UNITED STATES PATENT AND TRADEMARK OFFICE

Office Action Summary

09/751,185

DETAILED ACTION

FIG-5

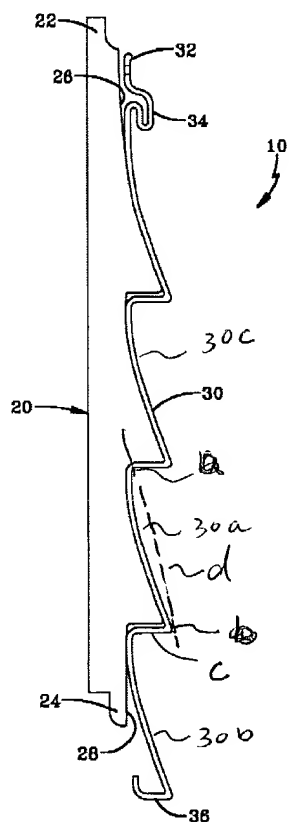
Manning et al. show and disclose, in Fig. 5, a vinyl siding panel comprising a facing panel (10) having a plurality of elongated planar portions (30) including a first planar portion (30a), a second planar portion (30b), and a third planar portion (30c), the facing panel having an upper edge having a nailing strip (32) and a tongue (34), and a lower edge having a groove (36) for snap-receiving the tongue (34) of adjacent panel in the installation, each planar portion

(30) having a width extending between a first edge (a) and a second edge (b) of the planar portion, said plurality of elongate planar portions (30a, 30b, 30c) being edge-by-edge connected each other by a seam (c) with a height to define a stepped contour between the adjacent planar surfaces, wherein each planar portion (30) has an average thickness in a range about 30 mils and 45 mils (0.03 -0.45 inches) (see col. 2, lines 35-36) and a width about 4 inches (see col. 3, line 5), each planar portion has a curved surface with a surface variance and a radius curvature, wherein the surface variance is defined from the outer surface of the planar portion to an imaginary straight line (d) connected between the first and second edges of the planar portion, and a reinforcement panel (20) made of a foam material being adhesively secured to the planar surfaces. Although Manning et al. do not define the seam having specific height and the planar surface having specific surface variance/radius curvature as claimed, Manning et al. discloses the planar surfaces having same specific width and thickness as claimed, the height of the siding panel is least 16 inches so the height of the seam appears to have at least about 0.5 inches, and having a curved surfaces with surface variance/radius curvature as similar as claimed.
